Marrickville Metro Shopping Centre

Section 75W Application to Modify Concept Plan MP_09_0191
December 2012

FIGURE 5 – PROPOSED MODIFIED NORTHERN ELEVATION TO SMIDMORE STREET

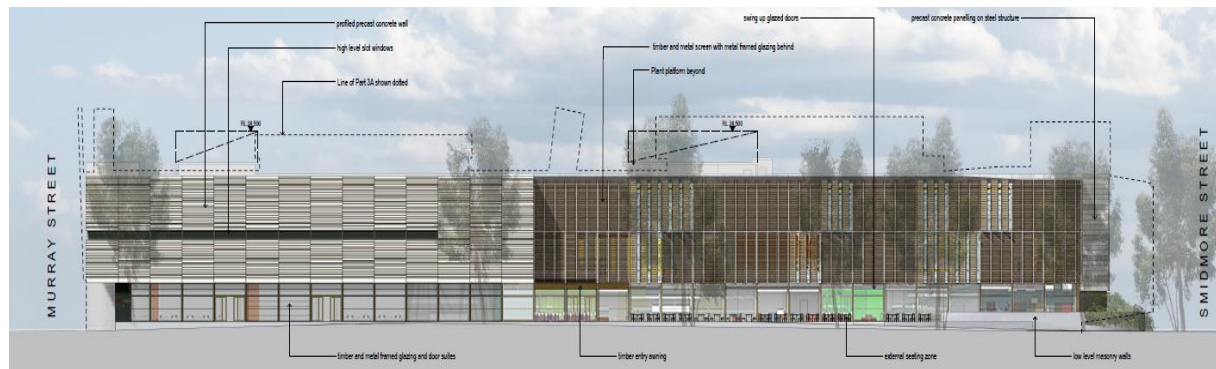
Figures 4 and 5 highlight some of the key changes from an external design perspective. In particular:

- The extension of the activated retail edge to the full extent of the site frontage;
- The reduced height of the project to the Smidmore Street elevation;
- The changes in materiality of the building.

FIGURE 7 – PROPOSED MURRAY STREET ELEVATION

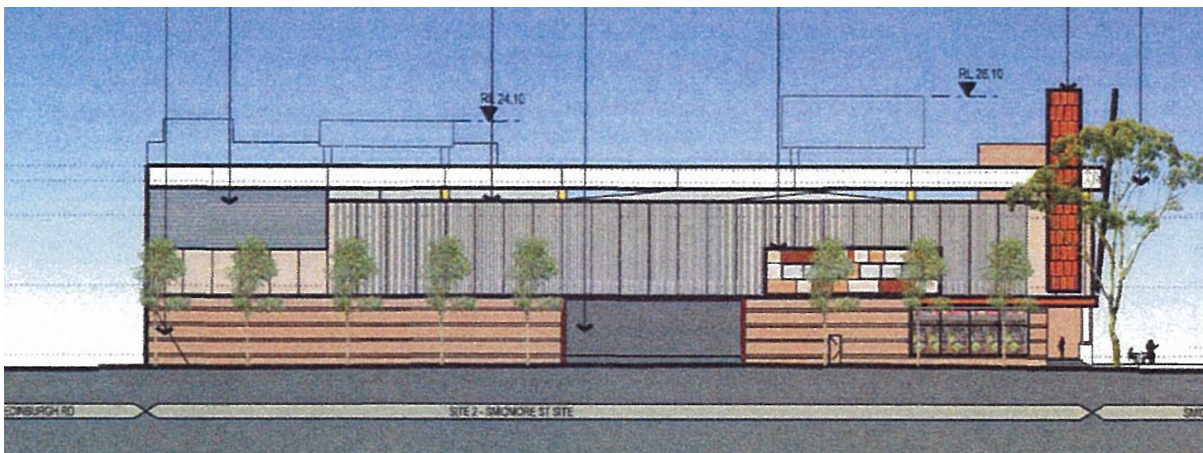
The proposed Murray Street parapet level of RL21.50 is 900mm above the current approved parapet (excluding the fire egress stairs) of RL20.60, a difference of 900mm. Given the adjacent industrial context, this minor increase in height is not considered to result in any adverse impact and achieves a streamlined building façade, which is a superior design outcome.
